From: [James Capp](#)
To: [Wessel, Tamera](#)
Cc: [Lacey CHITWOOD](#); [Steve CARTER](#); [Mike CASPER](#); [Chuck GIESIGE](#); [Stephen BENNETT](#)
Subject: Garfield Facility LLC - Part 70 Operating Permit Renewal No.: T035-45333-00028
Date: Friday, January 6, 2023 4:35:45 PM
Attachments: [2023.01.06 - Garfield - Comments on Draft Title V Permit Renewal signed.pdf](#)

**Re: Garfield Facility LLC in Delaware County
Part 70 Operating Permit Renewal No.: T035-45333-00028**

Re: **Garfield Facility, LLC**
Preliminary Findings
Part 70 Operating Permit Renewal
Permit No. T035-45333-00028
Public Comments
2601 West Mount Pleasant Boulevard
Muncie, Delaware County, Indiana 47302
MUNDELL Project No. M21013

Proposed Silt Sampling Locations
 Exide Technologies – Muncie Recycling Facility

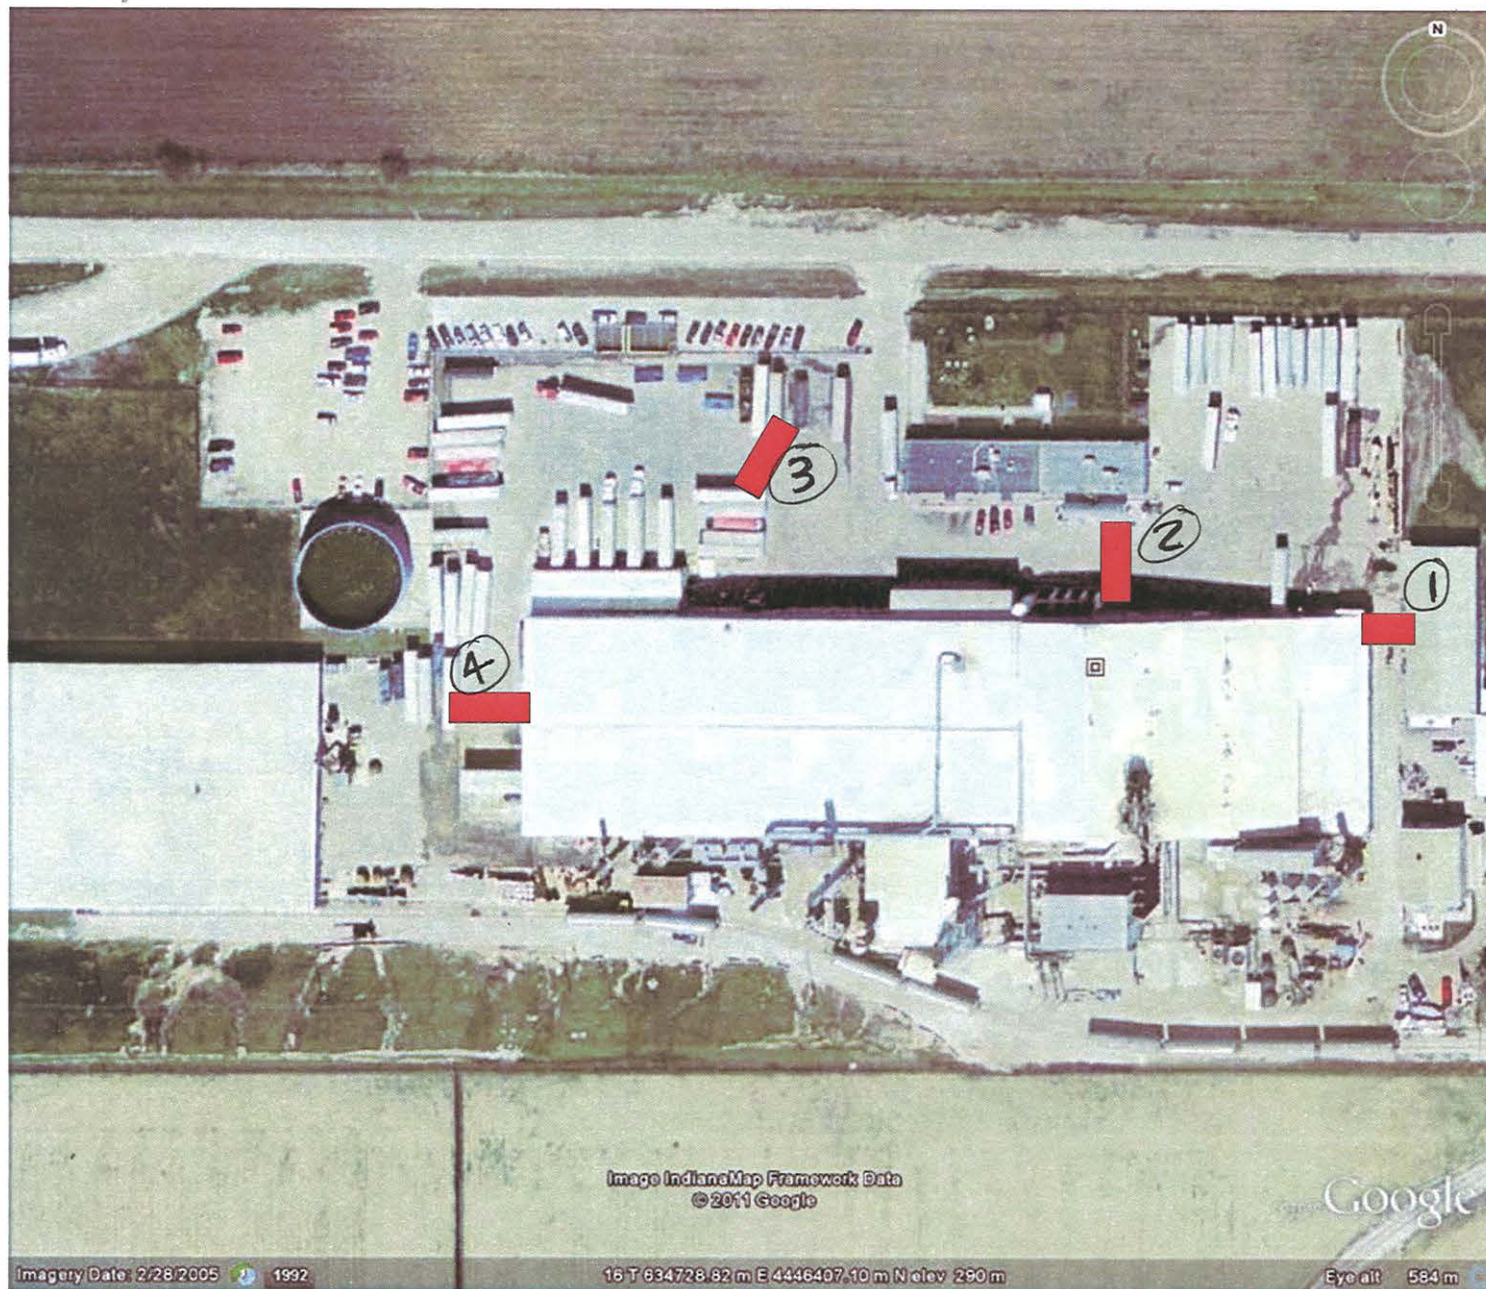
b. *Road Area Clarity*: Calculations presented on page 15 through 18 of Appendix A of the TDS separate paved roads by “sector” with each having a different silt loading factor. It is not clear how these “sectors” and corresponding silt loading factors are distributed across the property. For instance, review of Google Earth Imagery seems to indicate that there is one (1) drive entryway into the facility. As such, it would appear all vehicles included on “Sectors 1-4” would enter in this roadway, and thus should have the same silt loading factor for at least a portion of their drive. Please clarify this discrepancy to ensure the fugitive dust emissions are accurately and/or most conservatively estimated. In addition, a map clearly illustrating which portions of paved surfaces correspond to the respective silt loading factors would be most beneficial.

- b. *Road Area Clarity:* Calculations presented on page 15 through 18 of Appendix A of the TDS separate paved roads by “sector” with each having a different silt loading factor. It is not clear how these “sectors” and corresponding silt loading factors are distributed across the property. For instance, review of Google Earth Imagery seems to indicate that there is one (1) drive entryway into the facility. As such, it would appear all vehicles included on “Sectors 1-4” would enter in this roadway, and thus should have the same silt loading factor for at least a portion of their drive. Please clarify this discrepancy to ensure the fugitive dust emissions are accurately and/or most conservatively estimated. In addition, a map clearly illustrating which portions of paved surfaces correspond to the respective silt loading factors would be most beneficial.

Please see the map provided [“Muncie silt sample locations.pdf”].

Calculations provided on pages 15-21 cite each Sector separately and covering all the traffic routes.

Vehicles can move:

- Through Sector 2 and then exit the facility;
- Through Sector 2 to Sector 1, which is why all vehicles in Sector 1 are also accounted for in Sector 2;
- Through Sector 3 and exit the facility; or,
- Through Sector 3 to Sector 4 and then exit the facility. All vehicles in Sector 4 are also accounted for in Sector 3 except Junk Transfers, which only occur in Sector 4.

In the latest renewal, the paving of the truck lot was accounted for. In other words, calculations for all truck parking and turnaround were previously assumed to occur on unpaved roads, but the most recent renewal application accounted for the fact that the lot and turnaround area have been paved. Sampling was not conducted specifically on this sector, but it was conservatively assumed that the highest silt loading across all paved sectors applied to this paved truck lot.

Particle Size Distribution Report

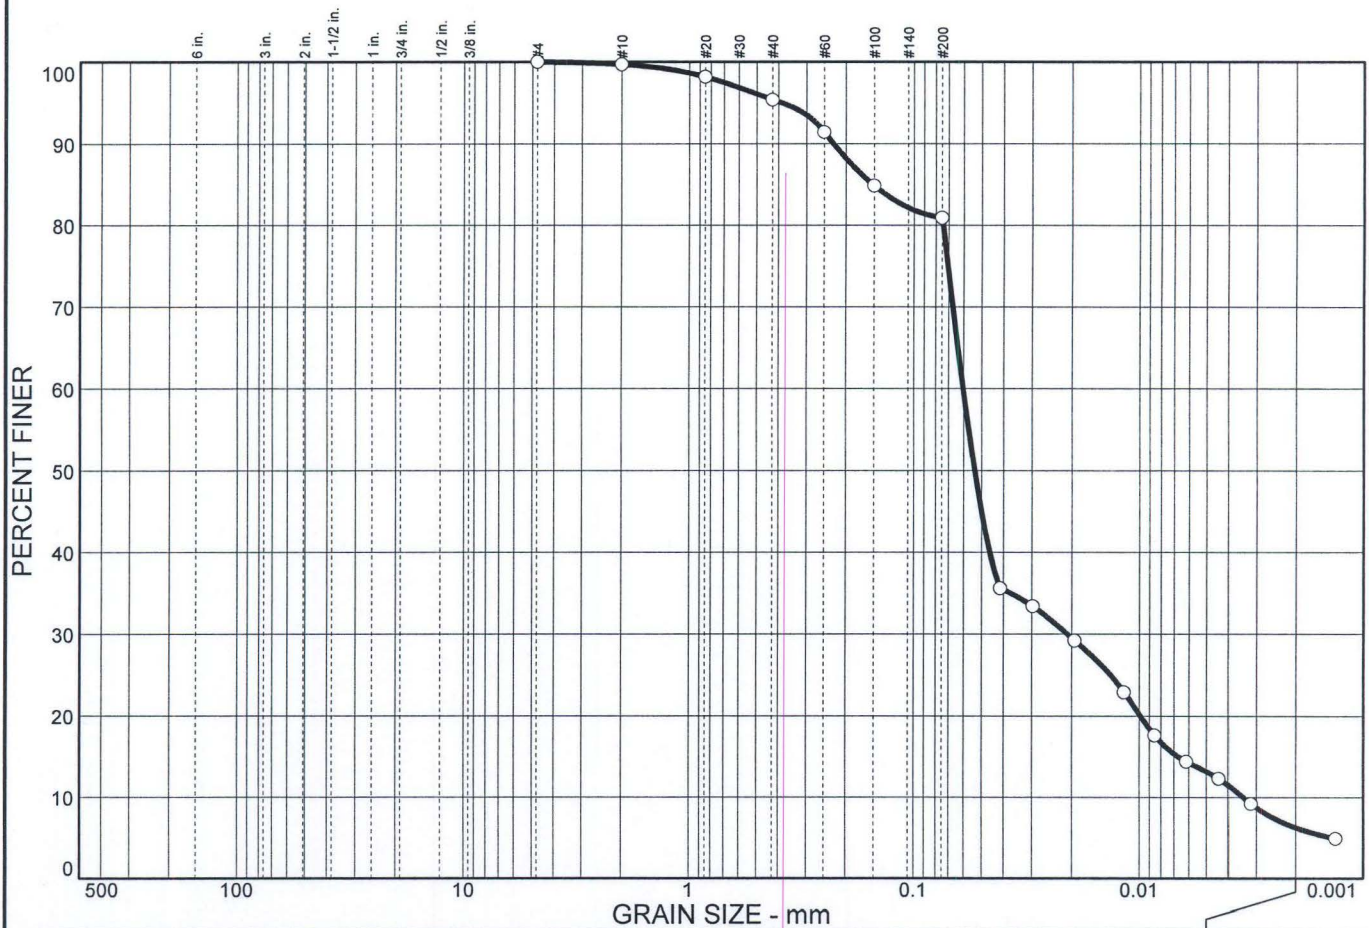
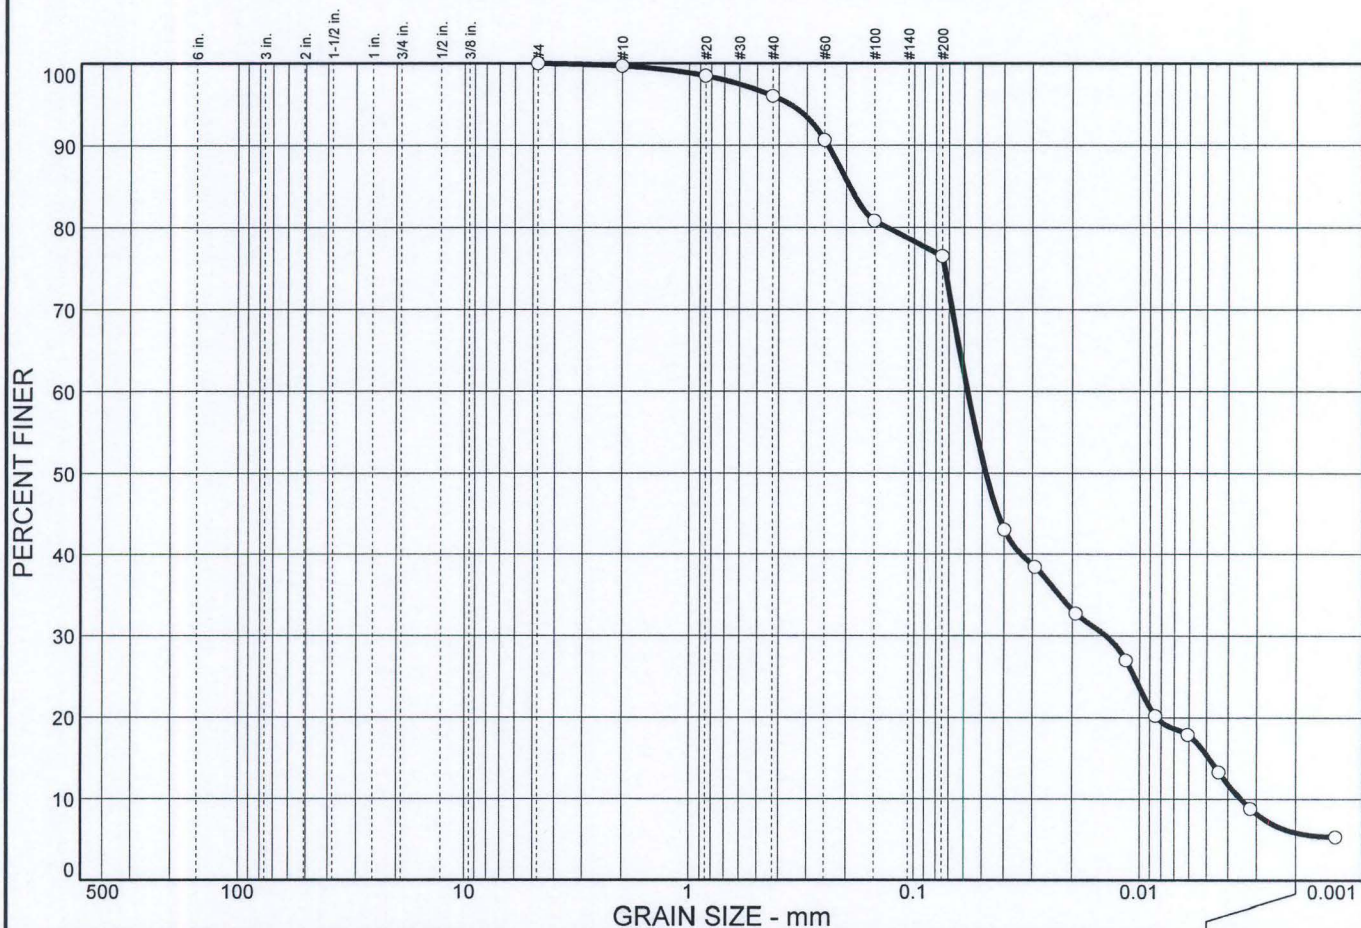
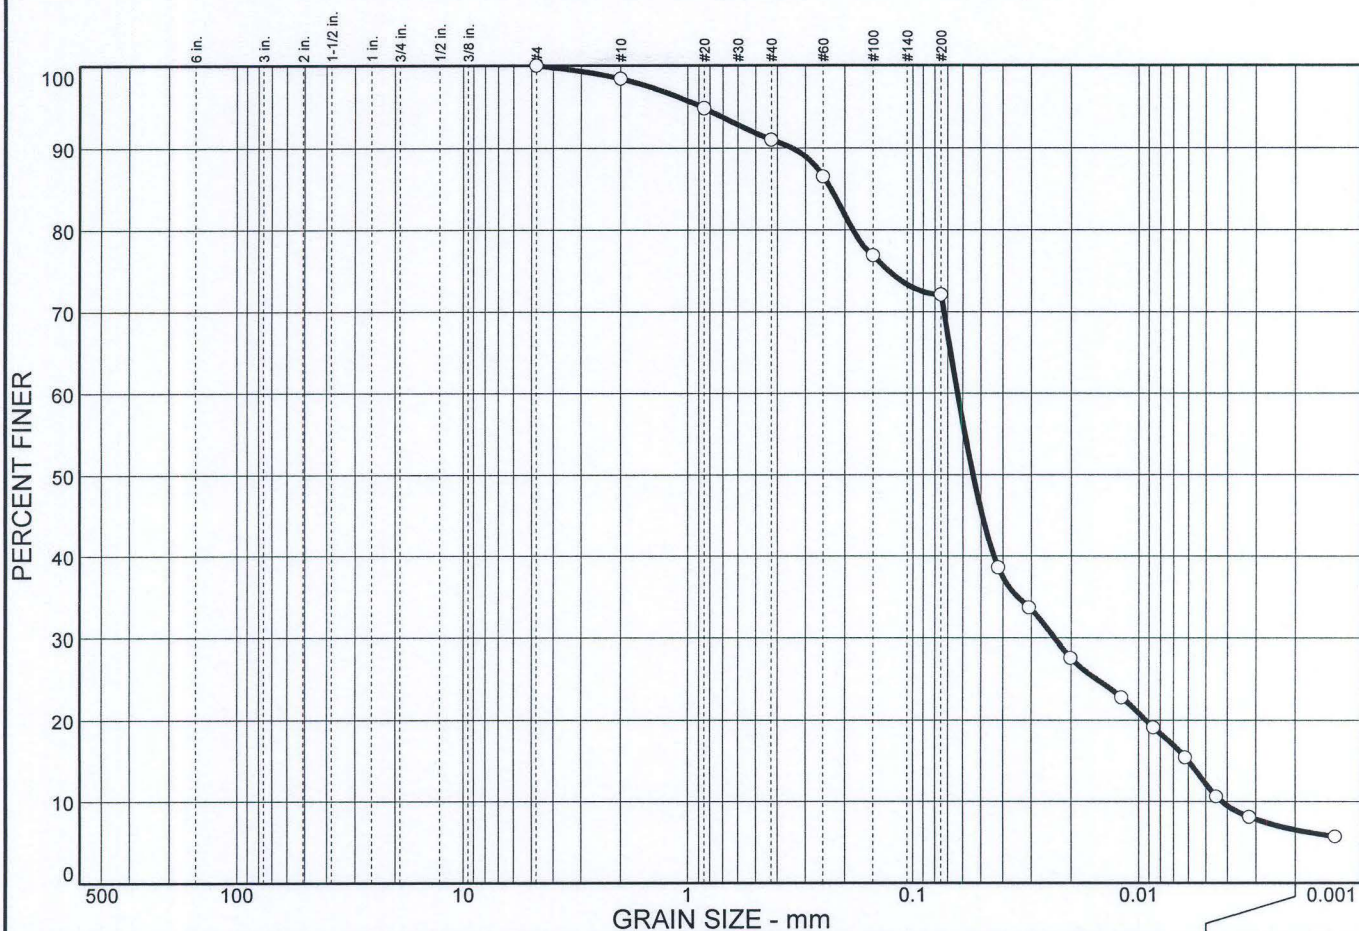
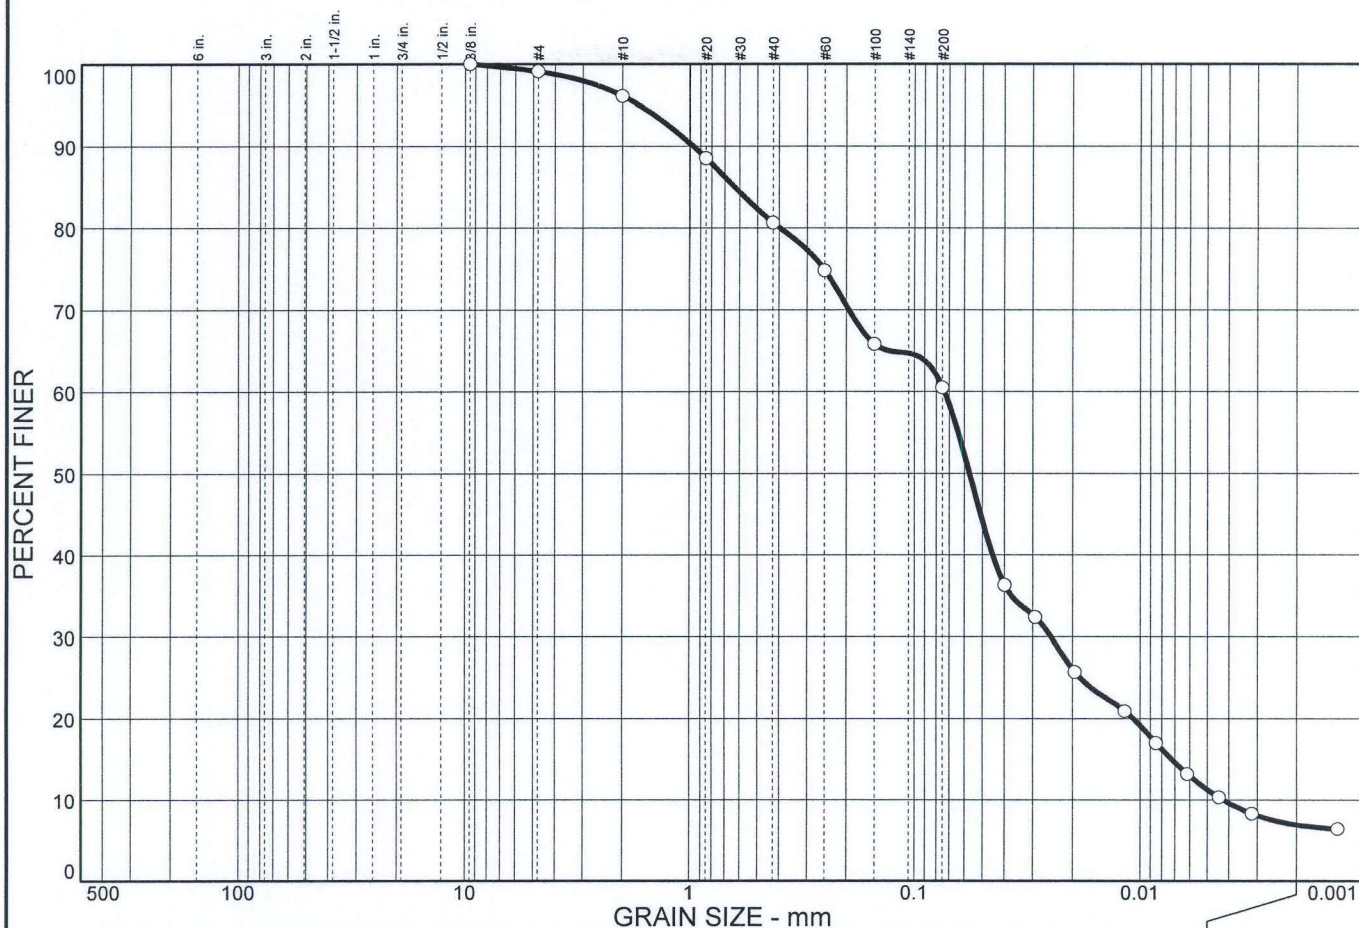
i. For public transparency, please provide the documentation for the testing methodology and results that determined these site-specific silt loading values.

- i. For public transparency, please provide the documentation for the testing methodology and results that determined these site-specific silt loading values.

Roadway dust loading levels and silt content were determined by sampling conducted in November 2011 following the procedure set forth in AP-42 Appendix C.1 and Appendix C.2. Surface dust samples were collected by facility personnel in accordance with the Appendix C.1 procedures. Laboratory analysis of the samples was conducted by Penniman & Browne, Inc. in accordance with Appendix C.2.

Silt content of each sample was determined by Penniman & Browne.

[see attached file “Exide 11-8-110001.pdf”]

Silt loading levels in g/m^2 (sL) as cited on pages 15 -21 of Appendix A of the TSD for each area (Sector) are simply the result of calculation of the weight divided by the surface area with the silt percentage applied, and appropriately converting units.

Sector ID	Silt %	Sample Weight (lb)	Area (sqft)	sL (g/m^2)
1	80.9%	0.54	720	2.96
2	76.5%	0.52	4300	0.45
3	72.1%	0.51	2000	0.90
4	60.5%	0.50	800	1.85
